SERVICE BULLETIN NO. 291

All *Kodak X-Omat* PROCESSORS

New THERMOWELL

H176_1015ACA
H176_1015AC

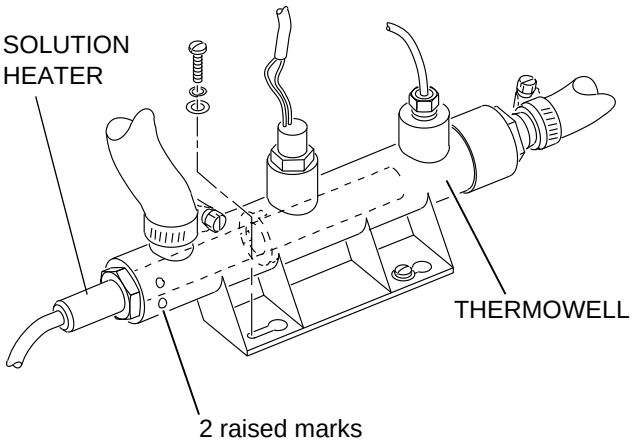
There is a new THERMOWELL, 5E1671 that replaces 8B7080. The new THERMOWELL has been improved by removing an interference where the SOLUTION HEATER threads into the THERMOWELL, which could cause the THERMOWELL to crack if the SOLUTION HEATER is over-tightened. The surface of the new THERMOWELL can be identified by 2 raised marks on the outside surface of the THERMOWELL near the SOLUTION HEATER.

Do not over-tighten the SOLUTION HEATER when installing it into the THERMOWELL. Use SEALANT 1C8022 or equivalent white silicone adhesive RTV SEALANT. Do not us pipe dope or silicone tape.

Installing the SOLUTION HEATER

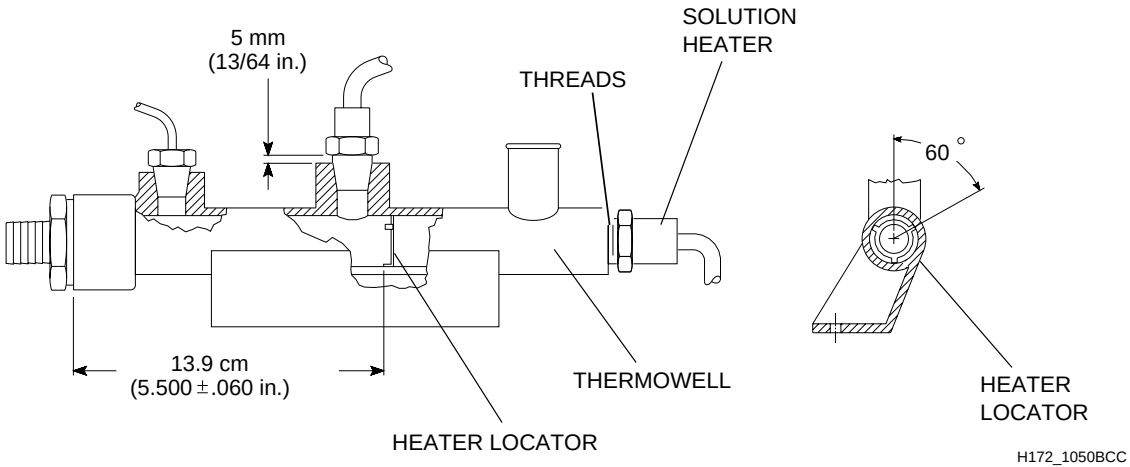
[1] Apply SEALANT 1C8022 to the THREADS on the SOLUTION HEATER.

[2] Install the HEATER LOCATOR, 607793 in the correct position inside of the THERMOWELL.

Make sure the TABS on the HEATER LOCATOR face away from the SOLUTION HEATER and positioned away from the OVER-TEMPERATURE TERMISTAT, if one is used.

[3] Install the SOLUTION HEATER into the new THERMOWELL. Tighten the SOLUTION HEATER no more than an additional 1/4 rotation by hand.

Caution
To prevent damage to the THERMOWELL, do not over-excessively tighten the SOLUTION HEATER.

Installing the THERMISTOR

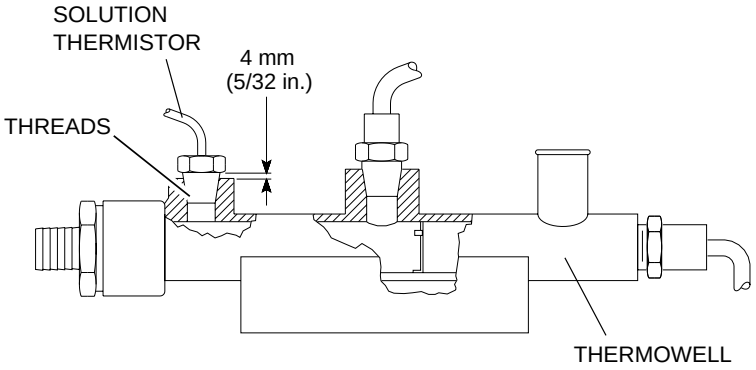
[1] Apply SEALANT 1C8022 to the THREADS on the new DEVELOPER THERMISTOR.

[2] Install the new THERMISTOR 4 mm (5/32 in.) from the THERMOWELL.

Caution
You must install the THERMISTOR at the correct distance from the THERMOWELL.

Installing the OVER-TEMPERATURE THERMOSTAT (if applicable)

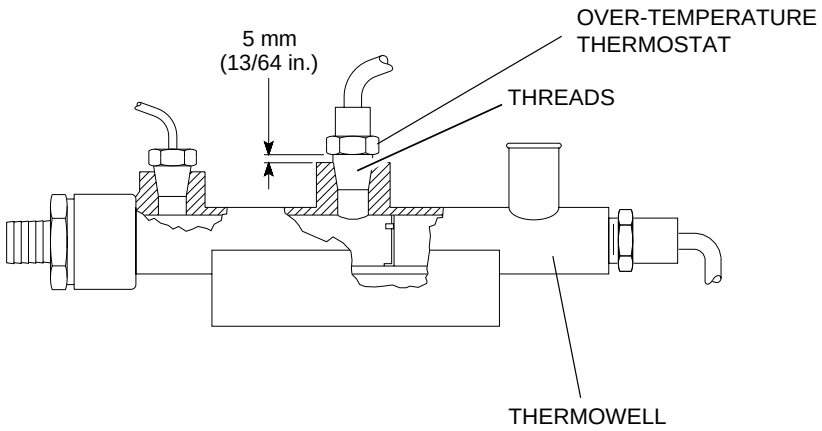
[1] Apply SEALANT 1C8022 to the THREADS on the OVER-TEMPERATURE THERMOSTAT.

[2] Install the OVER-TEMPERATURE THERMOSTAT 5 mm (13/64 in.) from the THERMOWELL.

Caution
You must install the OVER-TEMPERATURE THERMOSTAT at the correct distance from the THERMOWELL.
